SUBJECT: INFORMATION ON THE MULTI-MODE DIGITAL RADIO 2 (SUPERSEDES SL-227)

Effectivity: PC-12/47E Series Aircraft MSN 1720, 2001 and Up.

This Service Letter supersedes Service Letter PC-12 SL-227.

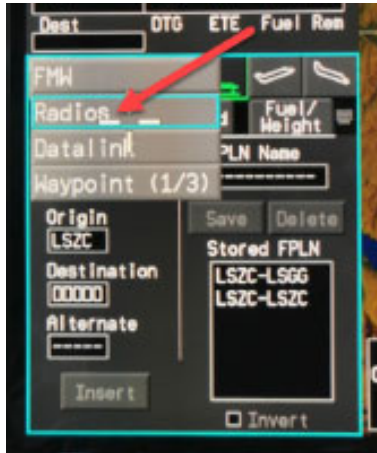
The radio datalink transmissions can be inhibited using the "DATA MODE" radio button on the radio window detail page with only STBY Bus powered.

NOTE 1: For aircraft battery starts, the radio window can be accessed on the lower MFD in STBY power mode. Make sure that the focus is on the FMS window and right click the scroll wheel selecting “Radios”.

Place the cursor over COM 2 and then press the “DETAIL” button on the Pilots PFD Controller. This will then display the selection to disable the “DATA MODE”. It is important to make sure that this is completed prior to requesting engine start clearance over the radio.

NOTE 2: The power up default status of this setting is ON, so it is required to be done at every Avionics System power up.
